# Access Compliance Report

## Public Rights-of-Way

Intersection ID: 10569	Main Street: PLYMOUTH_AV	Cross Street: BANCROFT_ST	Location:	N
ADA ID: 33D3B0418358	Ramp Type: PerpDiag	Initial Pass/Fail: Fail	Overall Compliance: No	Severity Score: 22.5
Codes/Mitigation Info/Possible Solution		Field Measurements/Component Compliance

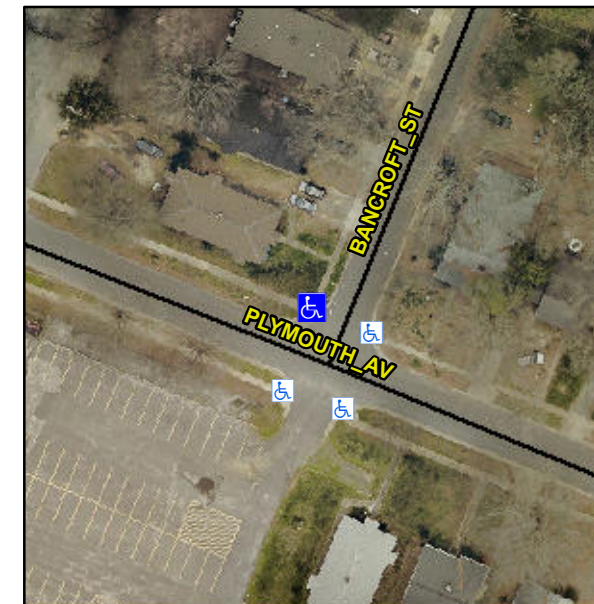
**Not Found, R304.5.1, R304.2.2, R304.5.3**

Compliance	Description	Data	Compliance	Description	Data
N/A	Ramp Length (in)	25.0	No	Ramp Slope (%)	9.3
No	Ramp Width (in)	47.0	No	Ramp XSlope (%)	2.2
N/A	Flare Type LT	N/A	N/A	Flare Type RT	N/A
N/A	Flare Slope LT (%)	N/A	N/A	Flare Slope RT (%)	N/A
N/A	Flare Traversable LT?	N/A	N/A	Flare Traversable RT?	N/A
N/A	Landing Length (in)	N/A	N/A	DWS Provided?	N/A
N/A	Landing Width (in)	N/A	N/A	DWS Contrast?	N/A
N/A	Landing Slope (%)	N/A	N/A	DWS Length (in)	N/A
N/A	Landing X Slope (%)	N/A	N/A	DWS Full Width?	N/A
N/A	Landing Curb? (Y/N)	N/A	N/A	DWS Offset (in)	N/A
N/A	Shared Landing?	N/A			
N/A	Gutter Ponding?	Yes	N/A	Gutter Slope (%)	N/A
N/A	Gutter Lip Ht (in)	N/A	N/A	Gutter X Slope (%)	N/A
N/A	Painted X Walk1?	No	N/A	Painted X Walk2?	No
	X Walk 1 Direction	To SW		X Walk 2 Direction	To SE
N/A	X Walk 1 Width (in)	N/A	N/A	X Walk 2 Width (in)	N/A
	X Walk 1 Slope (%)	3.2		X Walk 2 Slope (%)	1.1
	X Walk 1 X Slope (%)	0.4		X Walk 2 X Slope (%)	2.9

**Remove & Replace Curb Ramp With Two New Directional Ramps or Equivalent.**
